Technical Note 2

Project Name:	Cringle Road
Document No:	LM20066-DYSE-XX-ZZ-TN-C-0002
Revision:	P01
Date:	17/11/2020
Distributed to:	MCC LLFA
Originated by:	AJ
Client:	Towerhouse Systems
Content:	Response to LLFA

1 Overview

2 MCC comments

Appendix B - UU Asset Records

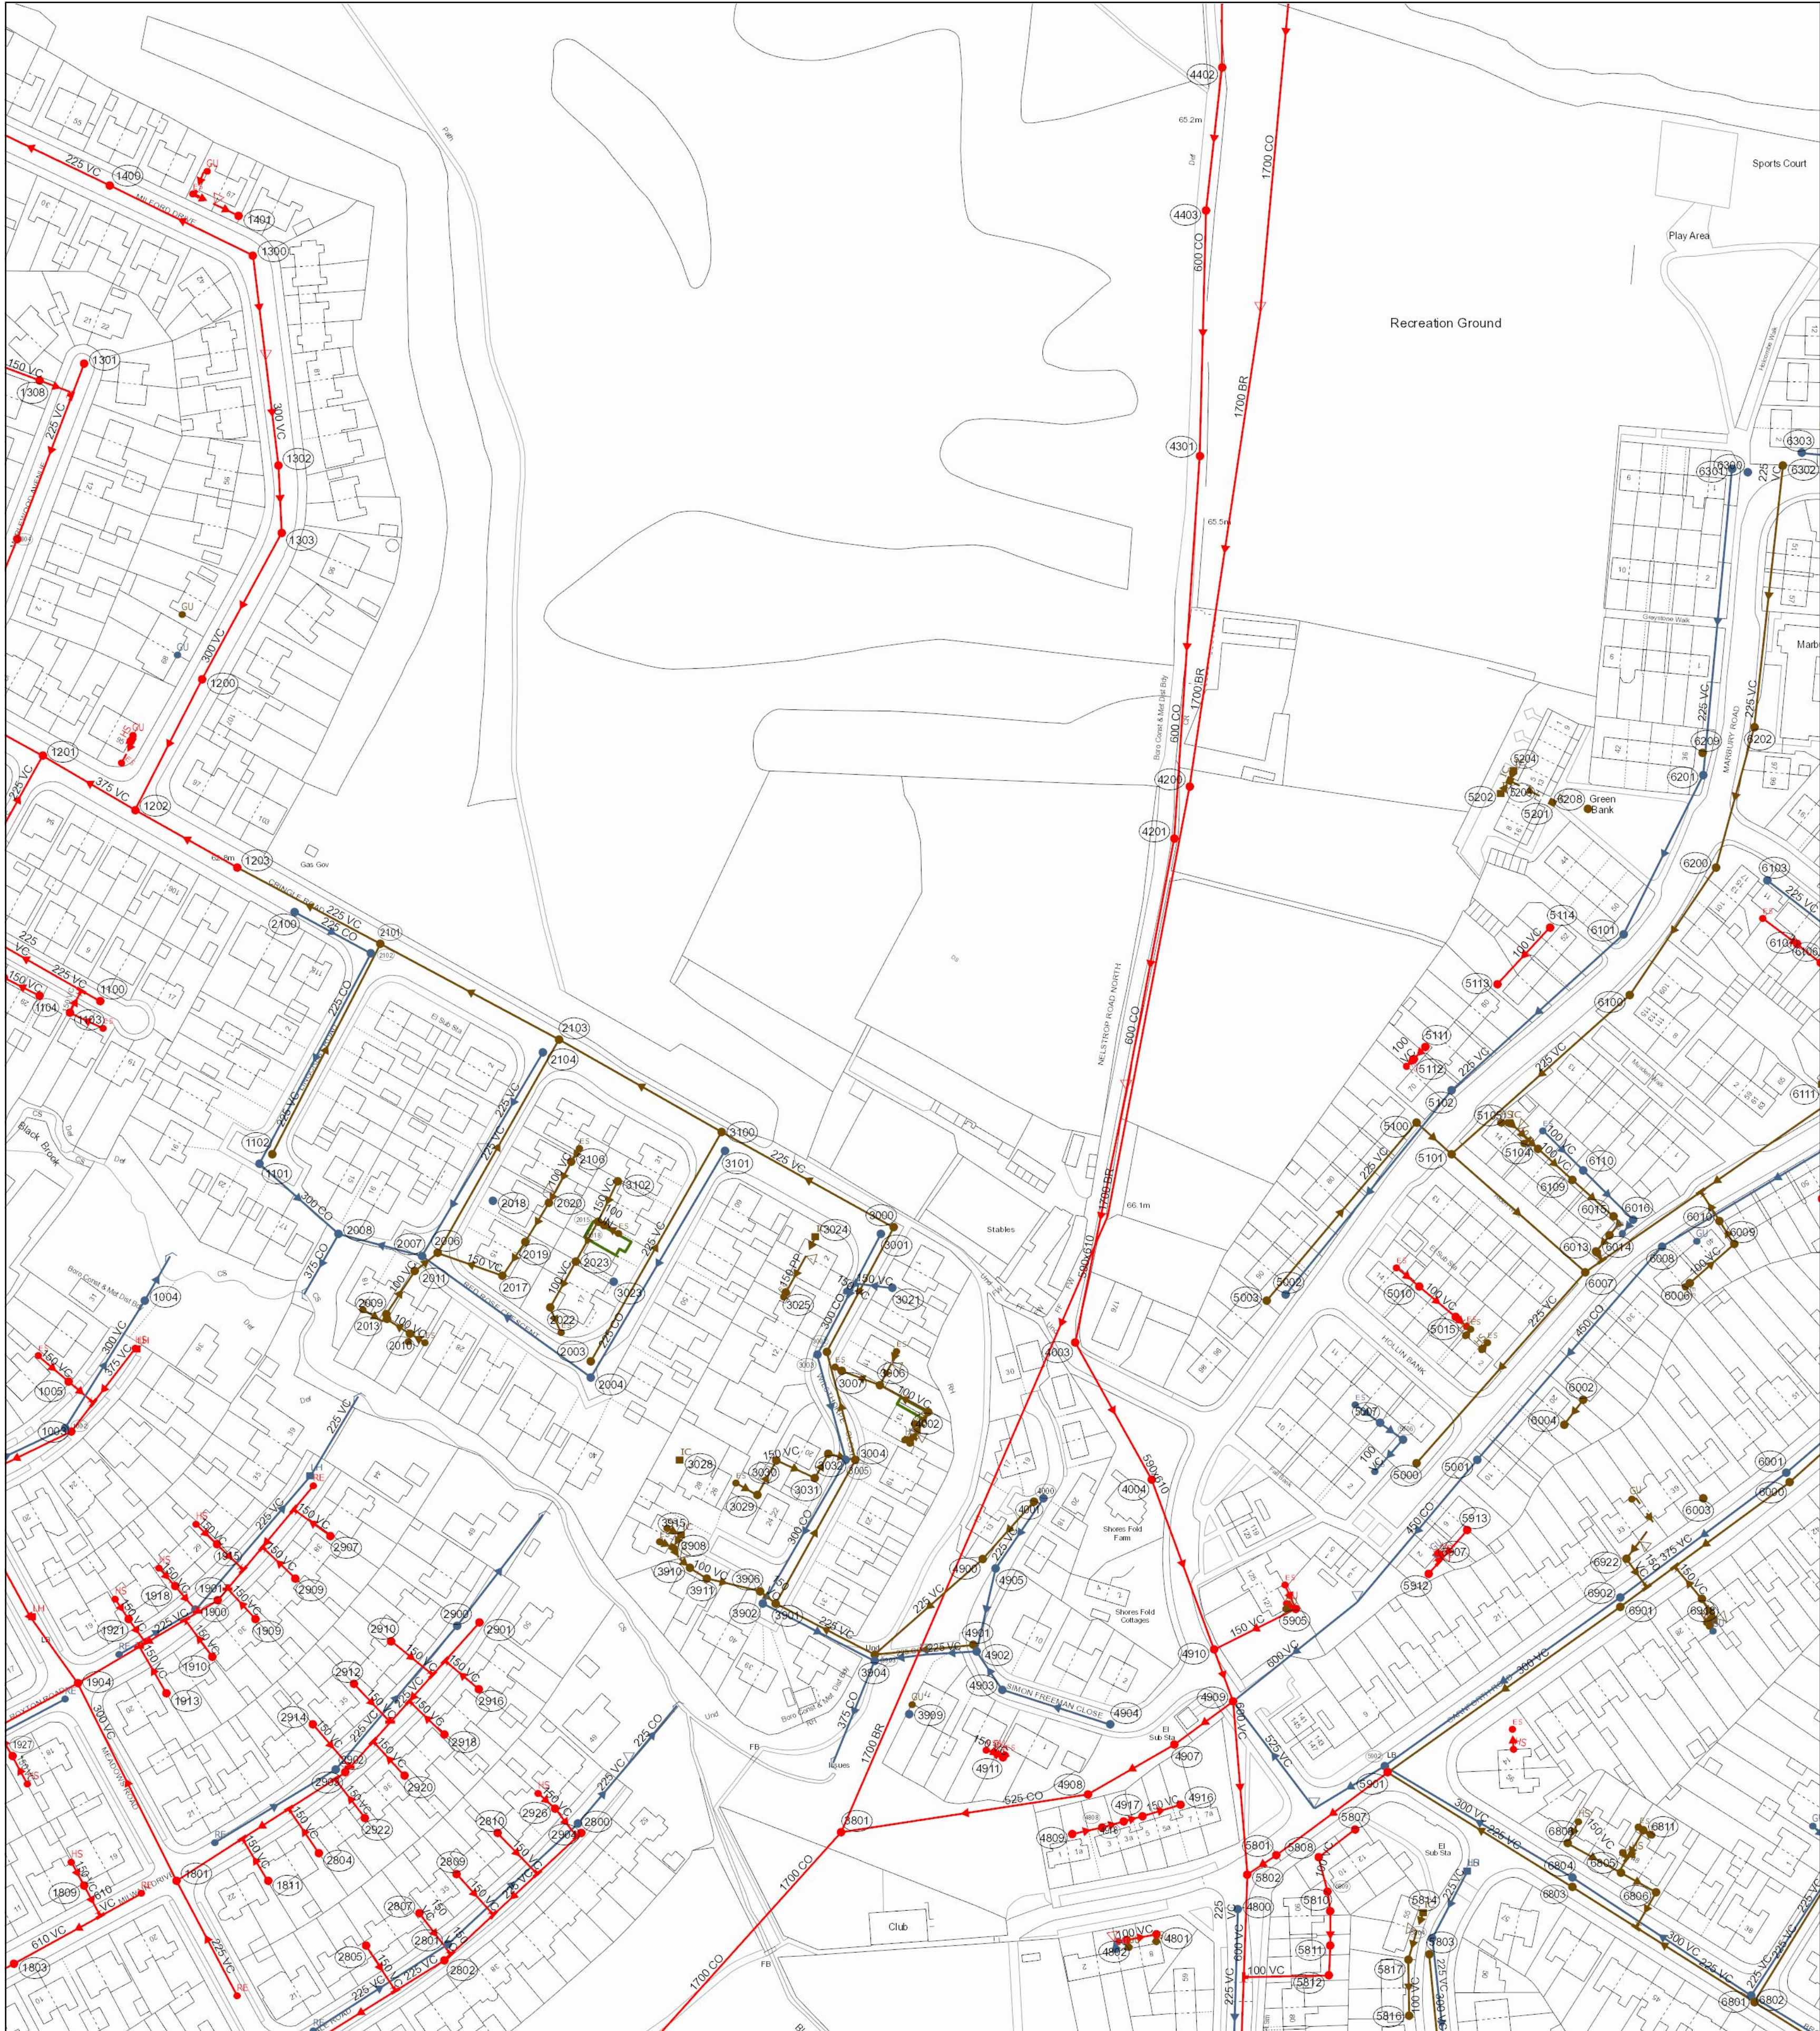
3. With regards to investigation into discharge to a proximal watercourse as per the hierarchy, we would typically advise the applicant to initiate discussions with the 3rd party land owner to make such a connection. However, in this case we are satisfied that, as a last resort, discharge into the surface water sewer would be acceptable on the premise that you present us with confirmation that it drains to the Black Brook.

Noted. Please see appended United Utilities asset records confirming that the surface water drainage discharges to Black Brook.
